Northampton Gateway
Roxhill

WALKING, CYCLING & HORSE RIDING
ASSESSMENT AND REVIEW (WCHAR)
REVIEW REPORT FOR PRELIMINARY
DESIGN STAGE

Northampton Gateway

Drawing NGW-BWB-GEN-XX-SK-C-SK48: Preliminary Design WCHAR Review Location of Problems

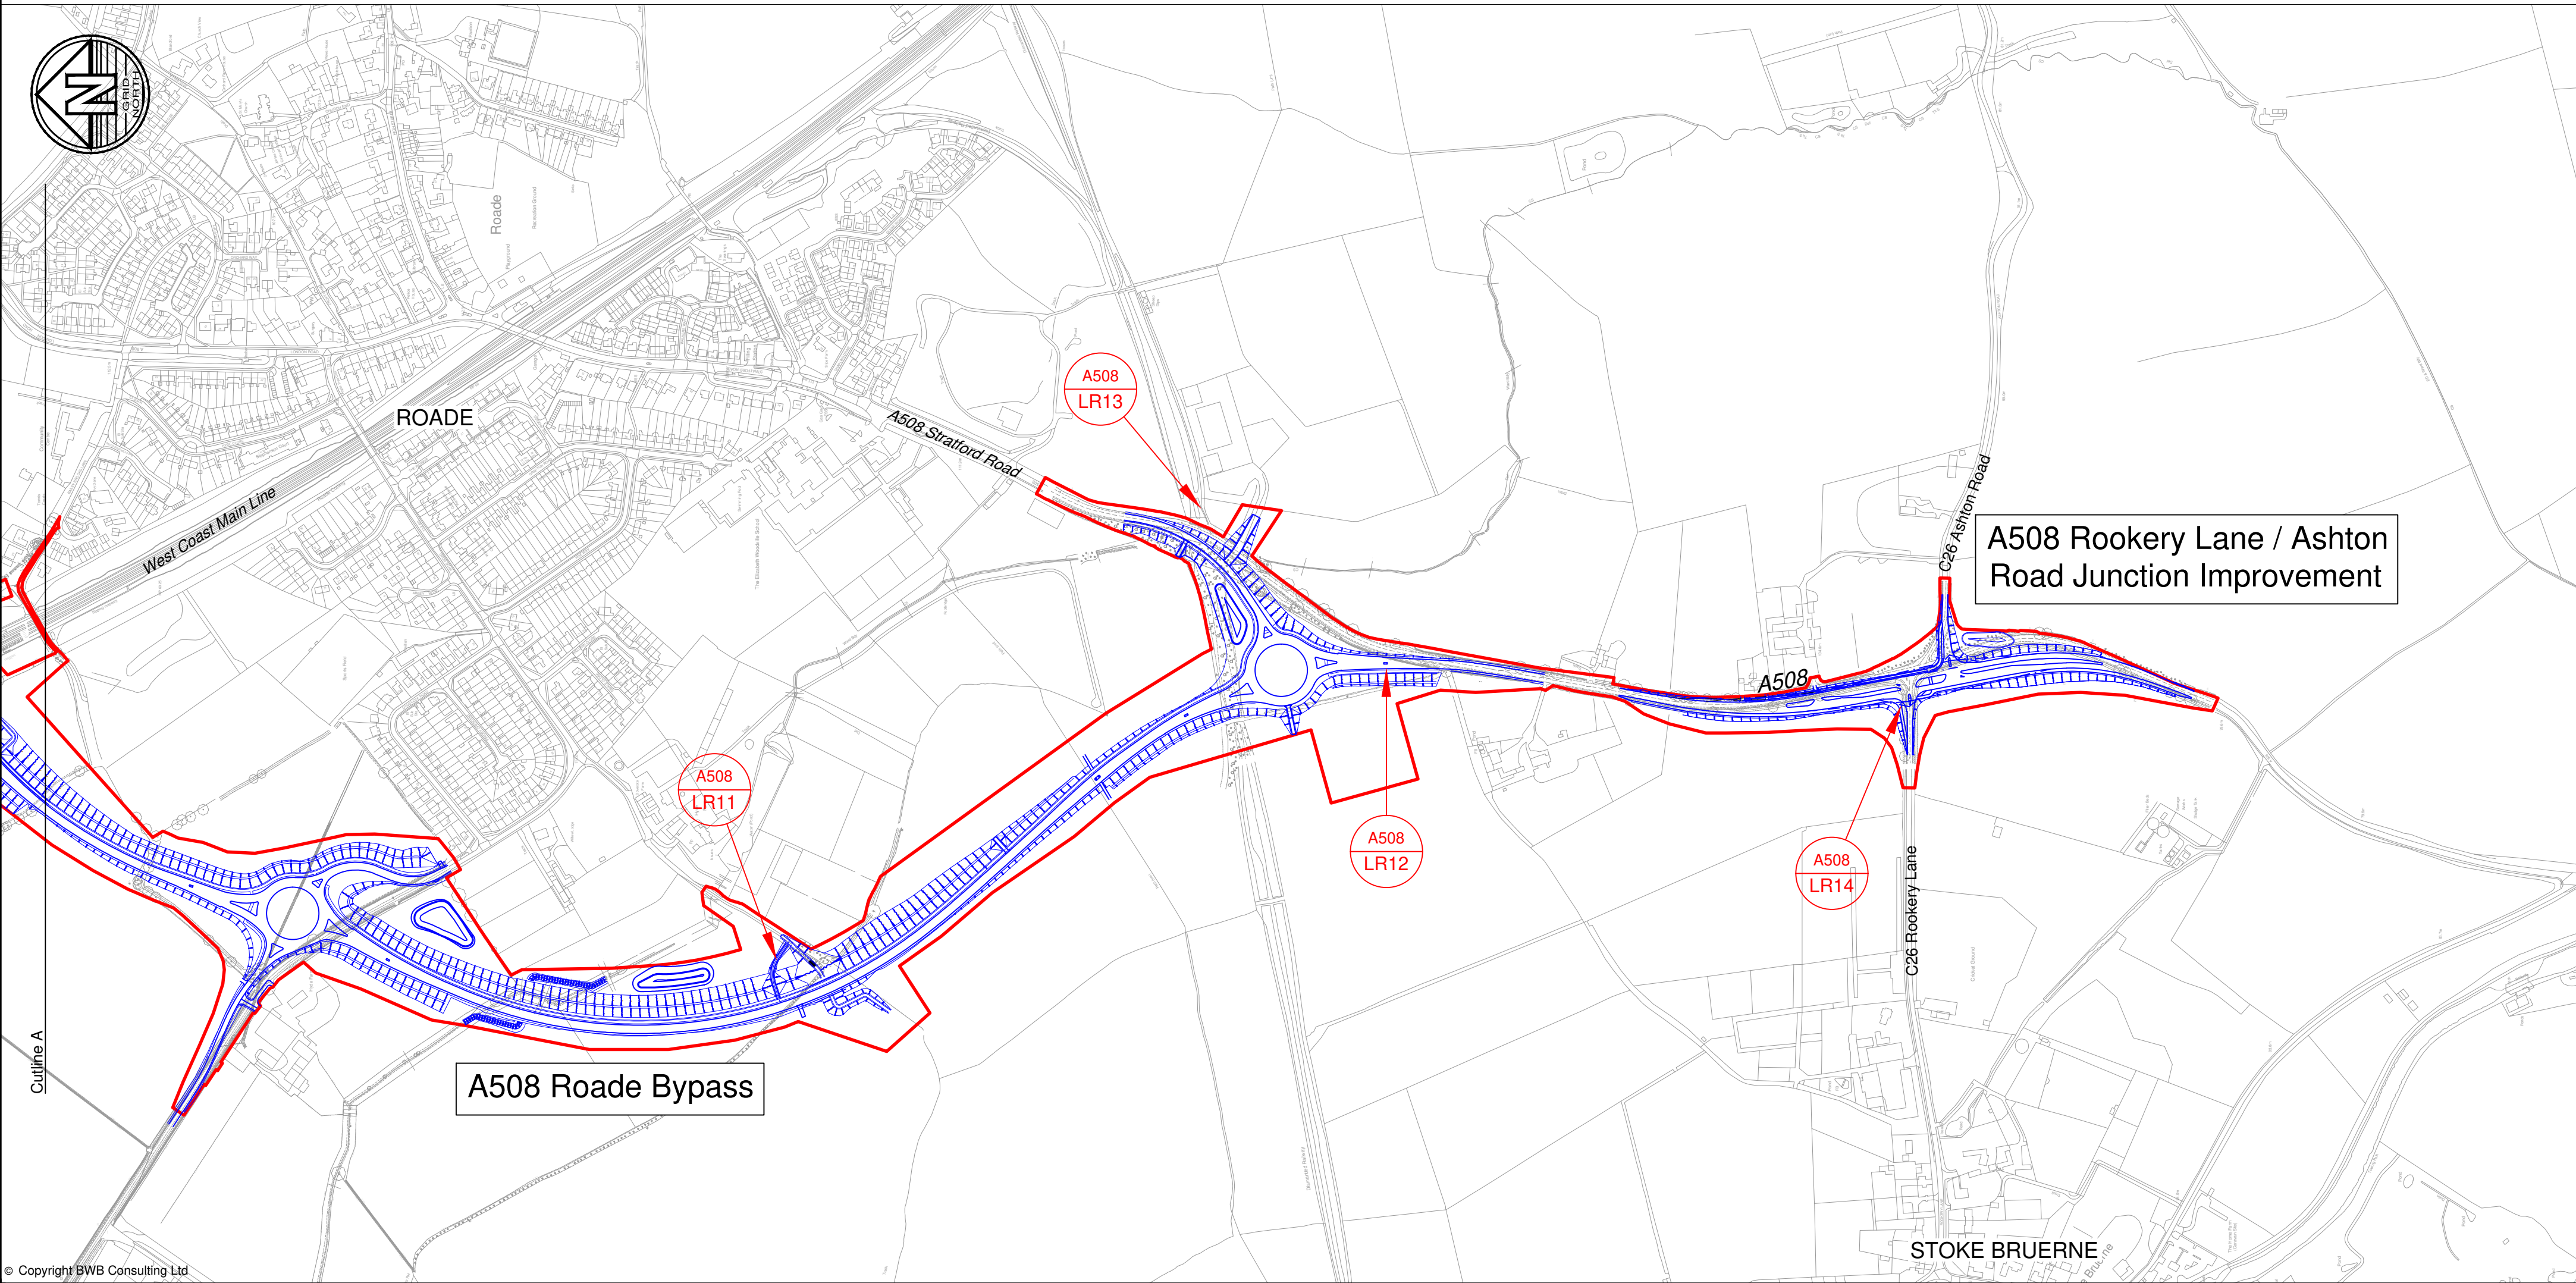
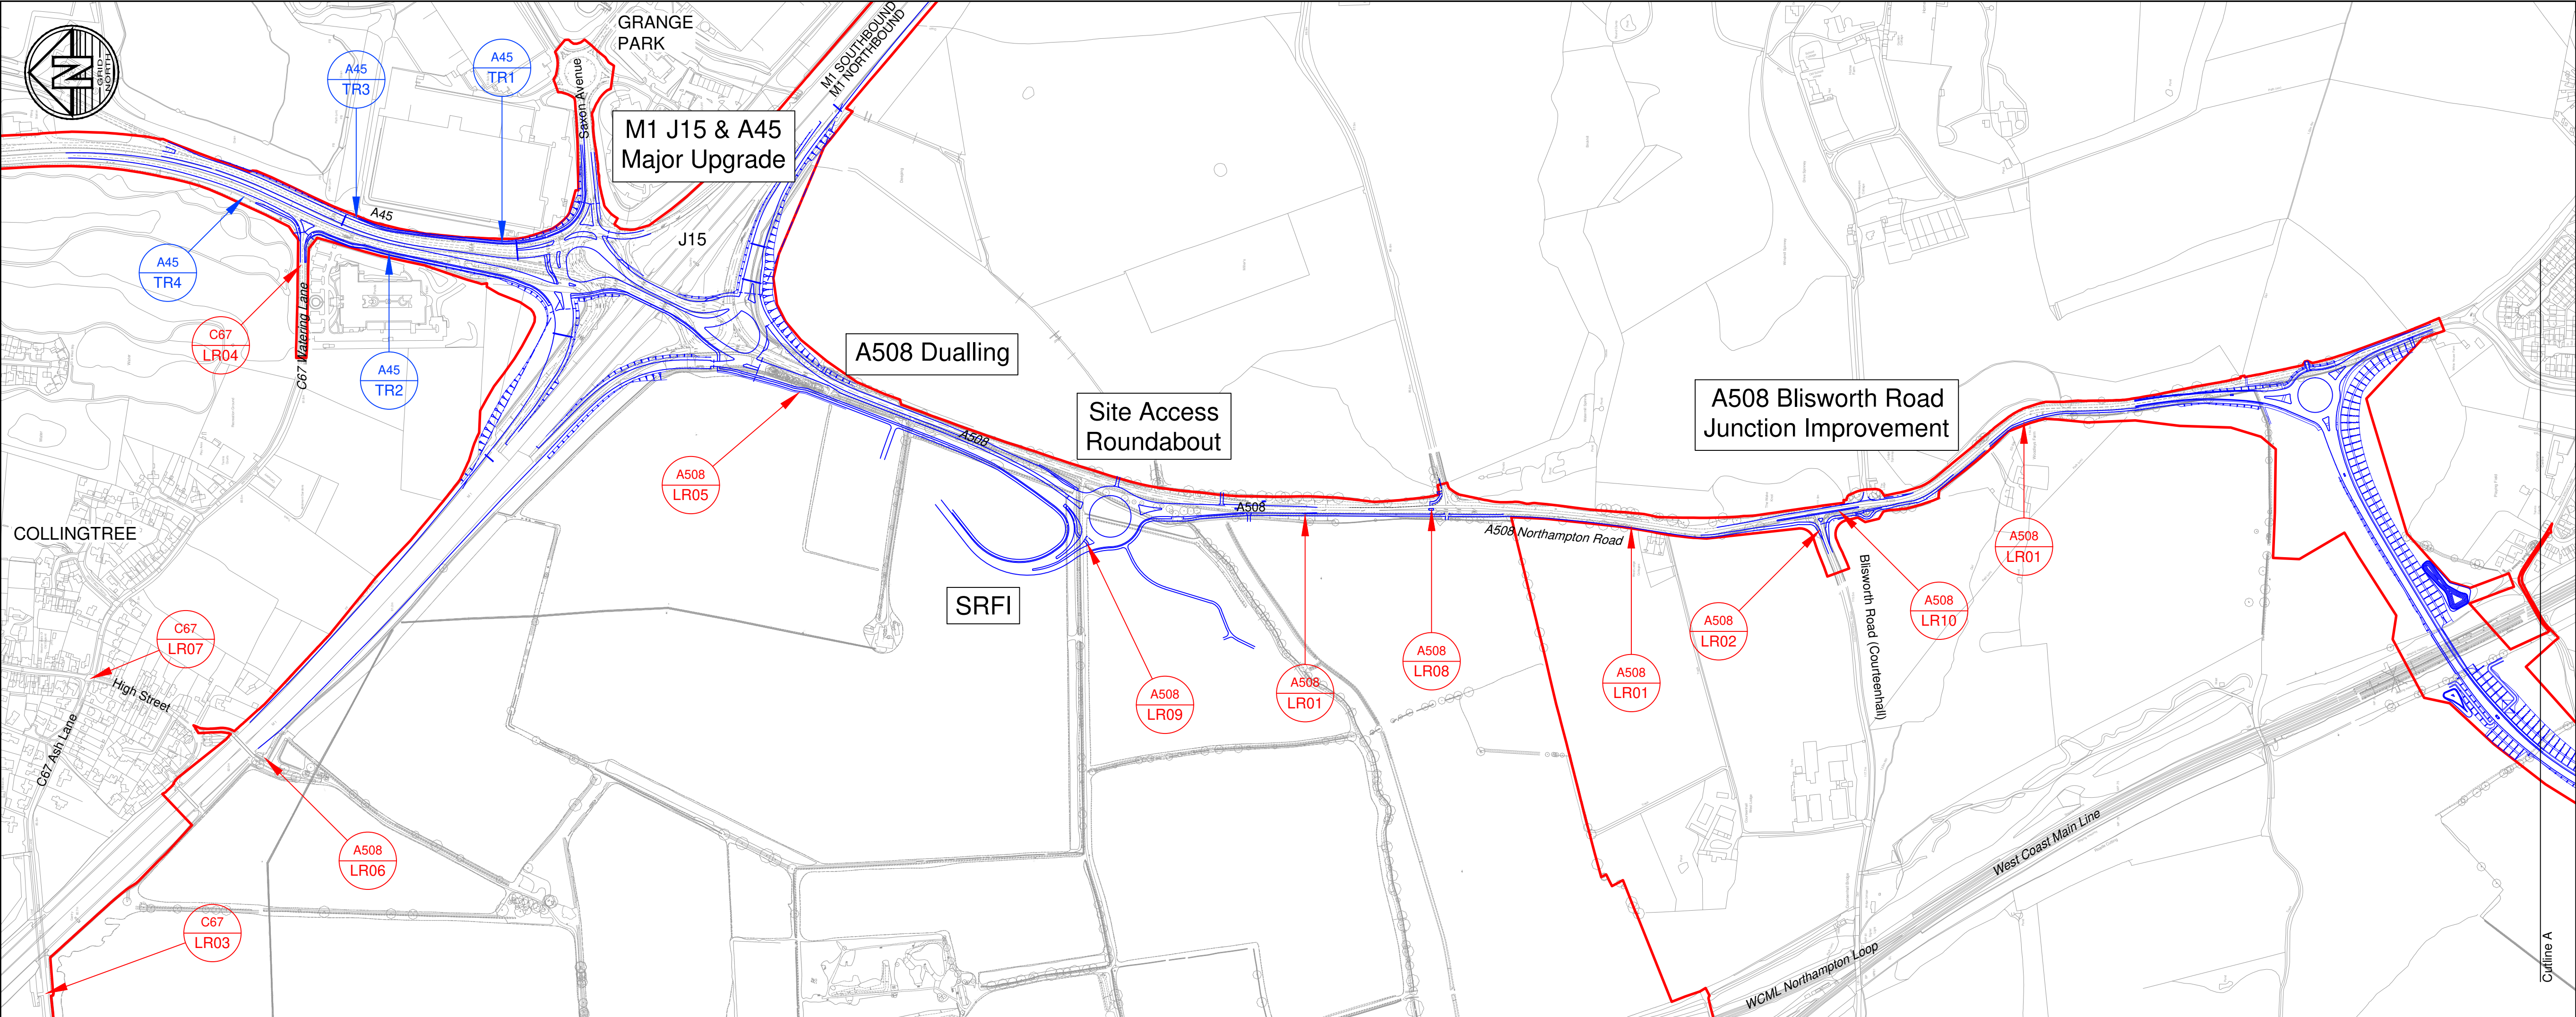
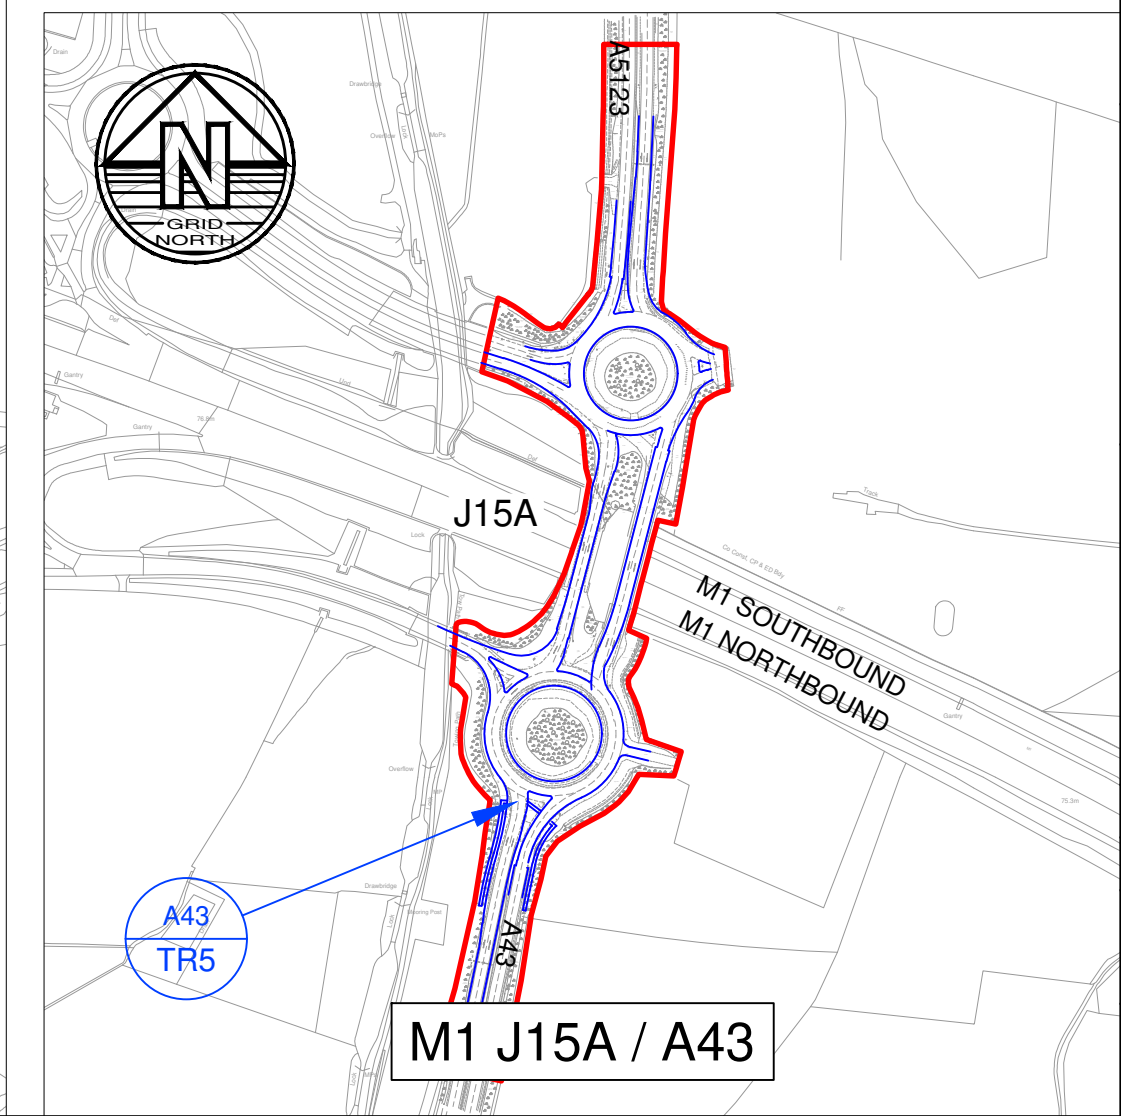
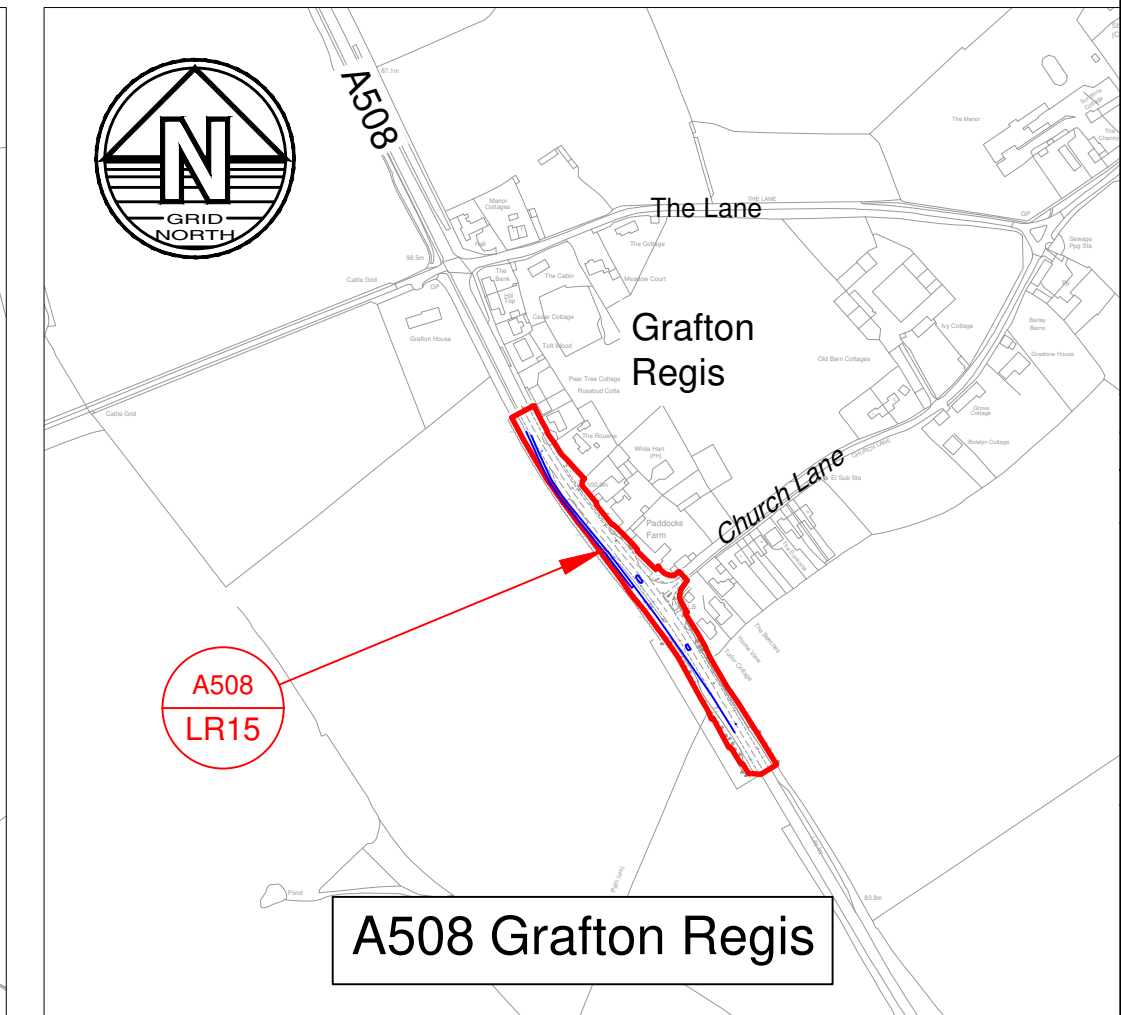
Problem Ref	Opportunity Ref	Problem	Outcome and Actions proposed
NGW_TR1	3	A shared use footway/cycleway is proposed from the A508 to Saxon Avenue, but its intended width is not always clear.	Outcome: The proposed width is 2m. Action: Provide further width annotations on the drawing for each section of the shared use facility between carriageway crossings.
NGW_TR2	4	A shared use footway/cycleway is proposed beside the A45, but its intended width is not stated.	Outcome: The proposed width is 3m plus a 1.5m safety margin. Action: Annotate the width of the shared use facility beside the A45.
NGW_TR3	5	The link to footpath LF2 is not clear.	Action: Annotate LF2 so it is clear on the drawings.
NGW_TR4	6	The design is silent on status of and maintenance responsibility for the cycleway beside the A45 north of Watering Lane.	Outcome: It has been established that this facility is within the trunk road boundary. The route via Collingtree is established for cycle traffic to the SRFI and hence the SRFI scheme does not need to meet this opportunity. We would recommend that this opportunity is reviewed by Highways England for funding as part of their cycling programme.

NGW_TR5	8	It is unclear how the uncontrolled crossing of the A43 northbound carriageway corresponds with the proposed signalisation.	Outcome: The crossing will be located beyond the stop line for the A43 Northbound approach. However, as the crossing on the A43 Southbound is to be uncontrolled, it is considered that the crossing of the A43 Northbound should also be uncontrolled. Whilst the AADT flow for the A43 southbound would mean that an at-grade crossing is not normally appropriate, it is considered that a) the scheme is an improvement over the existing uncontrolled crossing and b) the pedestrian flows are very low. Action: The drawings will be annotated to make the above clearer.

Problem Ref	Opportunity Ref	Problem	Outcome and Actions proposed
NGW_LR1	1	A 3m shared use footway/ cycleway is proposed, but it is unclear whether it will be made continuous by tying into a length of existing such facility, the status and condition of which are unclear.	<p>Outcome: The proposal is for a continuous 3m shared use footway cycleway facility from the M1 Collingtree Footpath bridge to the Roade Bypass (and then around the Roade bypass).</p> <p>It is noted that where it runs alongside the existing A508 within the existing verge the safety margin would be 0.5 rather than the 1.5m which will be provided where possible. It is considered that usage will be low and hence the instances of pedestrians and/or cyclists passing each other will be low. This means that during the majority of usage there will effectively be a greater safety margin as not all of the 3m width will be required.</p> <p>Action: The proposal will be made clear on the design drawings.</p>

NGW_LR2	1	A 3m shared use footway/ cycleway is proposed, but its treatment at Blisworth Road is unclear.	<p>Outcome: A cyclist crossing of Blisworth Road is proposed.</p> <p>Action: Clarify the proposals for crossing Blisworth Road.</p>
NGW_LR3	2	No shared footway/cycleway is proposed along Collingtree Road.	<p>Outcome: It is considered that there is no justification for the SRFI scheme to provide this facility and it is an opportunity for others to pursue. However, a footpath link should be made from Collingtree Road (near the railway bridge) into the SRFI to connect to the diverted footpath KX13.</p> <p>Action: Provide the footpath link.</p>
NGW_LR4	7	The Watering Lane footway extension does not reach the crossing point.	<p>Outcome: the footway extension is to link to the existing bus stop and pedestrians can use the signalised crossing facility to reach the footway on the north side.</p>

Problem Ref	Opportunity Ref	Problem	Outcome and Actions proposed
NGW_LR5	9	The footpath diversion route along the southeastern side is a footway / cycleway along the A508 and an additional 'footpath' route may be beneficial.	Outcome: It is agreed that an additional length of footway is beneficial. Action: Provide footpath type route through the landscaping area between the SRFI site and the A508 (this will be part of the KX17 diversion).
NGW_LR6	9	The diversion of footpath KX13 runs close to existing motorway, highway and railway corridors which may result in the route being unattractive.	Outcome: the concern is acknowledged and the route should be designed to be as attractive as possible Action: Provide more detail on the landscaping area between the SRFI site and the existing transport corridor and maximise the attractiveness of the route.
NGW_LR7	11	No improvement of visibility is proposed at Watering Lane/Ash Lane/High Street.	Outcome: Traffic calming and a 20mph speed limit were proposed but are removed from the scheme following a review with Northamptonshire County Council. It is considered that cyclist visibility from High Street crossing Ash Lane is acceptable.

NGW_LR8	13	It is unclear whether the traffic island at the Quinton road junction is to be adapted as a central pedestrian refuge.	Outcome: The existing refuge should be improved to provide a cycle crossing Action: Clarify the drawings to show the design intention, providing a central refuge for cyclists.
NGW_LR9	14	The drawings are not clear whether pedestrian facilities at the SRFI junction are to be shared facilities with cyclists.	Outcome: The facilities will be shared use except the signal crossing which will only be for pedestrians Action: Clarify the drawings to show the design intention for footway/cycleway facilities at the SRFI junction.
NGW_LR10	17	It is unclear whether the traffic island at the Blisworth Road junction is intended for pedestrian use. No route to the bus stop is shown.	Outcome: A crossing should be provided along with a link to the bus stop Action: Amend the design to provide an island suitable for pedestrian use, and identify the bus stop clearly on the drawing.

Problem Ref	Opportunity Ref	Problem	Outcome and Actions proposed
NGW_LR11	19	The width of the proposed link from the Roade bypass to bridleway KZ10/RZ1 is unclear.	Outcome: The proposed width is 3m. Consideration was given to bridleway status but rejected on the basis that this could lead horses onto the A508 where there are no equestrian facilities proposed. Action: Show the width of this short link on the design drawings.
NGW_LR12	19	The means of discharging equestrians onto the carriageway, and the link between bridleway RZ6 and the footway, are unclear at the tie-in of the Roade bypass to Stratford Road.	Outcome: The existing bridleway terminates on the A508 and there are no onward facilities for walkers, cyclists or horse-riders. The proposed design would provide a shared use footway/cycleway from the end of the bridleway connecting into the wider facility being constructed as part of the Roade Bypass. Action: clarify the design drawings to show how the end of bridleway RZ6 is to be treated, and how it is to connect with the footway / cycleway to the north.

NGW_LR13	19	Reference to footpath KZ12 is omitted from the drawings.	Action: Add footpath KZ12.
NGW_LR14	21	It is unclear whether, and to what extent, footways at the Rookery Lane and Ashton Road junction are intended for use by pedestrians in conjunction with the central island.	Outcome: The east-west Rookery Lane to Ashton Road (and vice versa) route is intended for both pedestrians and cyclists. Action: Clarify the design to show the footways and cycleways around the junctions.
NGW_LR15	22	An uncontrolled crossing of the A508 via a central refuge is shown at Grafton Regis, but no linking footway is shown to the bus stop.	Outcome: A footway should be provided Action: Add a footway linking the central refuge to the bus stop.
